Site Accessibility Evaluation

Fire Station 7

Accessibility Evaluation

SUBJECT: Fire Station 7 Self-Evaluation

Finding 184758 Main Photo

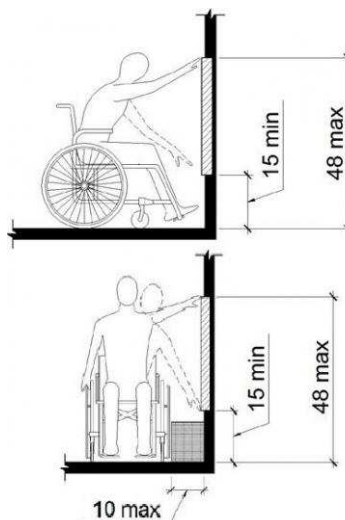
The door bell is positioned too high for either a side or front approach.

The door bell is mounted at 55".

Lower the door bell to 48" maximum.

Finding: 3

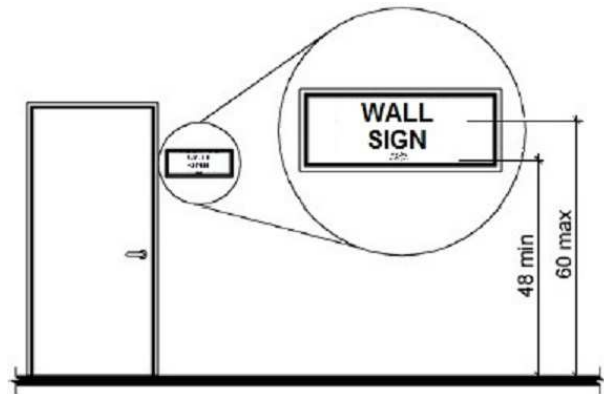
Door bell should have a sign to make it more conspicuous.

There is not a wall sign indicating the location of the door bell.

Add information sign indicating door bell.

Finding: 4

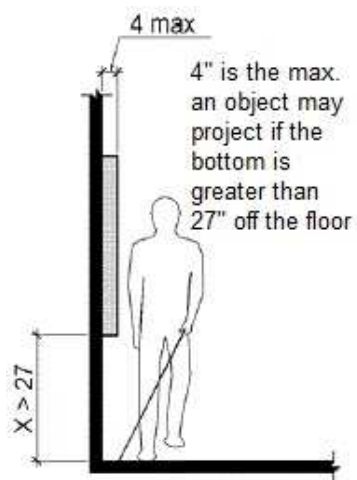
The ash can projects more than 4 inches into the circulation path.

The ash can projects more than 4" into the path of travel.

Remove the ash can.

Finding: 5

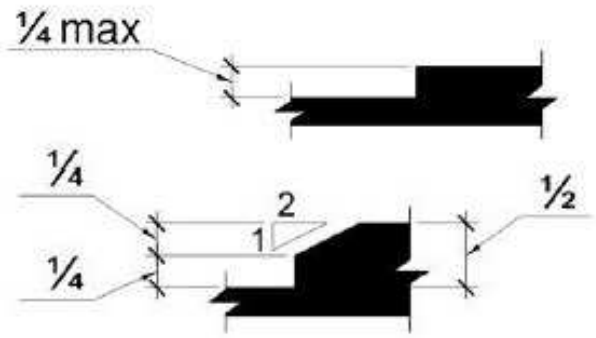
The walkway contains abrupt vertical edges and/or variations over a 1/4 inch.

There is 1" vertical displacement in the sidewalk at the entrance.

cut out and re-pour or add metal bridge plate.

Finding: 6

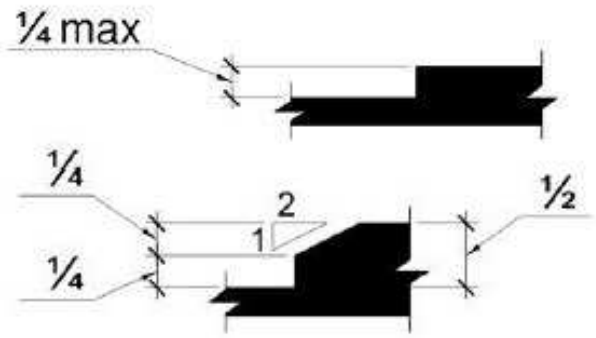
The walkway contains abrupt vertical edges and/or variations over a 1/4 inch.

There is 3/4" vertical displacement where the driveway apron and sidewalk join.

Remove and replace concrete panels as needed to achieve compliance, or grind edge to less than 1/2".

Finding: 7

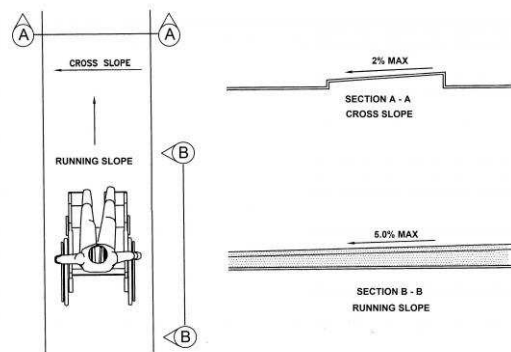
The accessible route on the site contains running slopes greater than 5% and has not been constructed as a ramp (i.e. handrails, wheel guides, etc.).

The running slope of this section of sidewalk is 6.9%.

Remove and replace concrete panels as needed to achieve maximum running slope of 5%.

Finding: 8

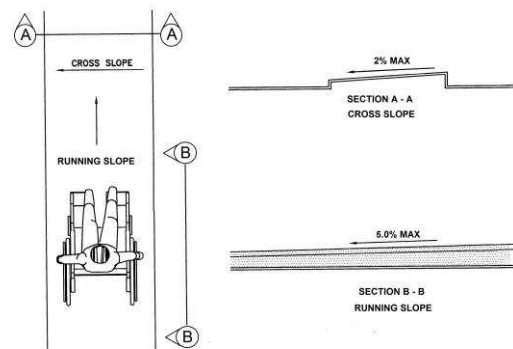
The accessible path of travel contains cross slopes greater than 2%.

The cross slope of these six panels exceeds 3%.

Remove and replace panels as needed to achieve 2% maximum cross slope.

Finding: 9

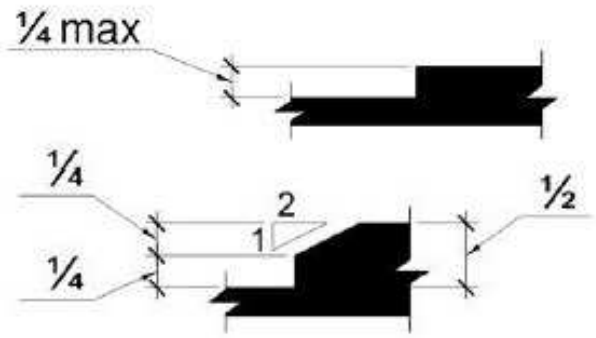
The walkway contains abrupt vertical edges and/or variations over a 1/4 inch.

There is considerable spalling in this sidewalk, causing 1/2" or greater vertical displacement.

This section of sidewalk would be avoided as would the cross slope in this area if we wrap up and use asphalt as the route.

Finding: 11

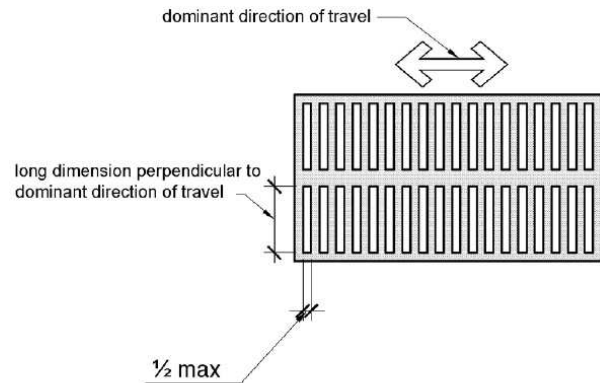
The curb ramp surface has openings that are greater than 1/2 inch.

There are no detectable warnings on this curb ramp at Academy Blvd.

There is a 1" gap at the top of the ramp where it meets the landing.

Fill the gap and add detectable warnings.

Finding: 12

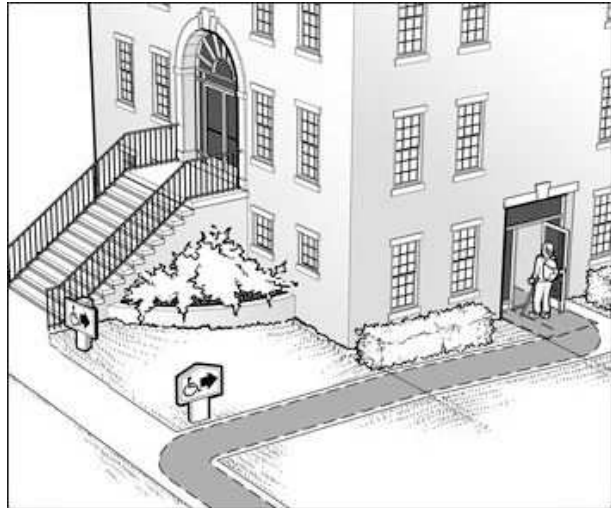
The building entrance is not located on an accessible route.

There is not an accessible route from the current and proposed parking to the fire station or in the public right of way

Put in AC route from parking area behind fire station (FS); explore installing AC route inside FS perimeter along west side of fence. If not in the interior we should look at adding sidewalk on exterior of fence in the PROW.

Finding: 13

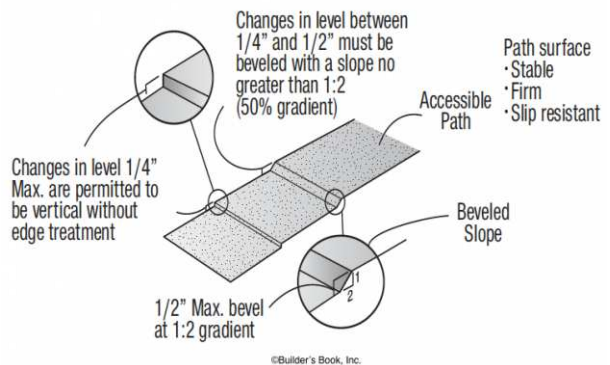
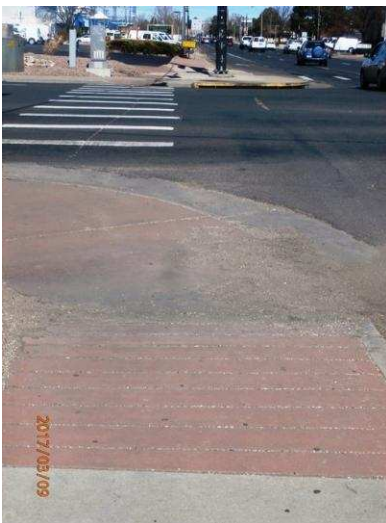
The surface of the curb ramp is not firm, stable and/or slip resistant..
The curb ramp also is missing detectable warnings.

There is considerable debris build-up at the curb ramp at Academy Blvd and Palmer Park Blvd.

Keep the curb ramp clear of debris. This may require evaluating and re-routing stormwater runoff or moving/completely redoing the ramp. Also detectable warnings need to be added to the ramp.
